22nd October 2026

Kent and Essex Inshore Fisheries and Conservation Authority
Paragon House
Albert Street
Ramsgate
Kent
CT11 9HD

Sea Link Project (EN020026) - Comments on the Applicant's responses to the Secretary of State's requests for information

Figure 1: Kent and Essex IFCA District, Thames Estuary Cockle Fishery Order 2024 (TECFO24) and the Cockle Fishery Flexible Permit Byelaw (CFFPB), cockle fishery management areas, and the Sea Link Project Boundary-EN020026.

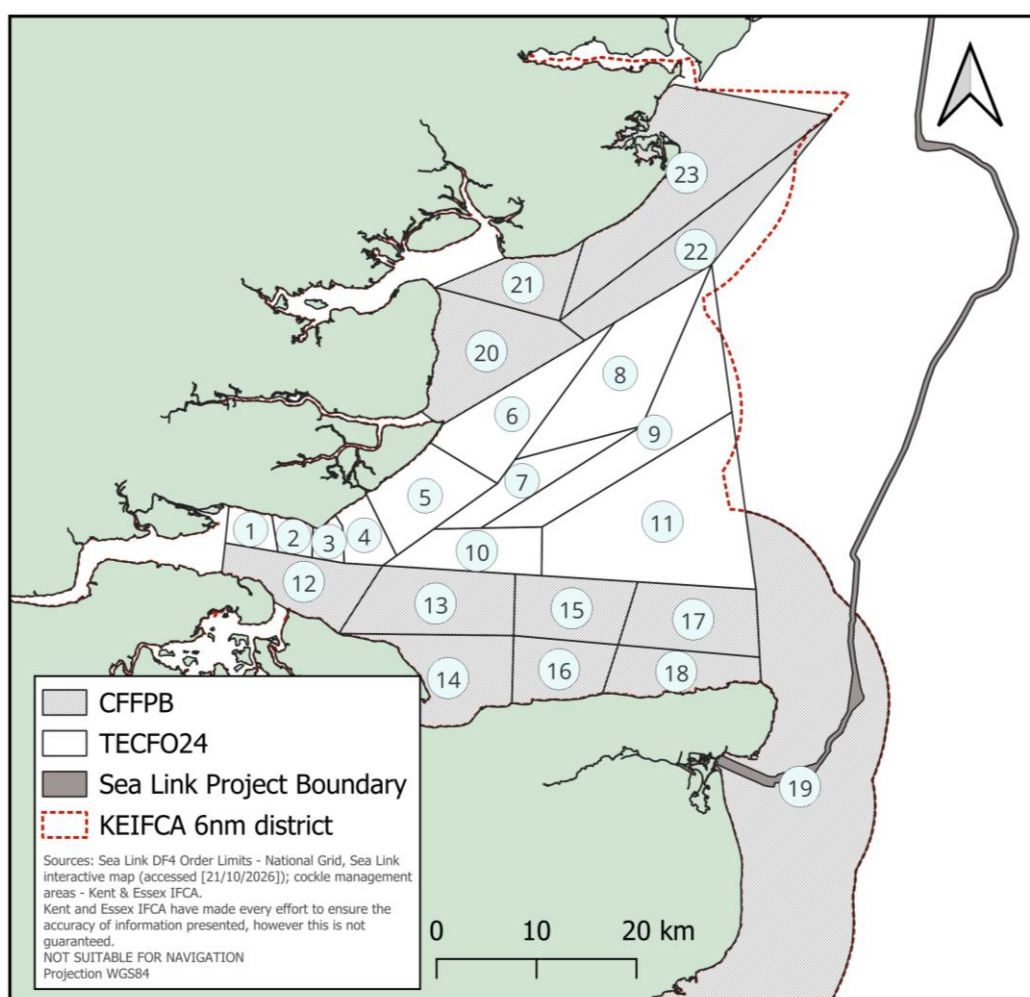
12. Separately, KEIFCA wishes to highlight potential interactions with cockle fisheries in the outer Thames near the district boundary. Indicative mapping using the publicly available Sea Link DF4 Order Limits dataset places the boundaries of cockle management Areas 22 and 23 approximately 8.5 km from the nearest offshore project boundary, with the boundaries of Areas 18, 17 and 11 within approximately 10 km (Figure 1). These are approximate distances between management-area boundaries and indicative project limits, rather than distances to surveyed cockle stocks. KEIFCA requests that the Applicant verify the spatial relationship between the proposed seabed works and cockle beds within these areas, using the latest project alignment and available stock-distribution data, and explain whether the assessment adequately addresses potential sediment transport to those beds.

13. KEIFCA acknowledges that the Applicant has modelled sediment dispersion for both ploughing and jetting scenarios and assessed effects on shellfish in Document 6.2.4.3(B), paragraphs 3.9.54-3.9.60. Paragraph 3.9.58 reports modelled fine-sand suspended sediment concentrations of 100 mg/l at distances of up to 11 km, associated with resuspension at multiple locations rather than a single continuous plume. This does not establish adverse effects at cockle beds within the identified outer Thames management areas. However, KEIFCA requests that the Applicant identify the relevant modelling outputs and explain the predicted concentrations, exposure durations and deposition at these beds. The response should explain how the sensitivity of cockles, including relevant life stages, supports the conclusion of negligible effects, rather than relying solely on general statements about shellfish mobility or tolerance of suspended sediment. Where the existing assessment does not adequately resolve these matters, supplementary assessment should be provided.

14. Table 1.2 of the CEMP provides indicative installation periods for the Pegwell Bay to the Sunk in 2028 and the Aldeburgh to the Sunk in 2029-2030. KEIFCA requests clarification of when, and for how long, seabed-disturbing activities would occur in the sections with potential to affect the identified outer Thames beds. This should explain how the proposed programme relates to the cockle fishing season and periods of spawning and spat settlement, and whether repeated disturbance across successive seasons has been adequately considered.
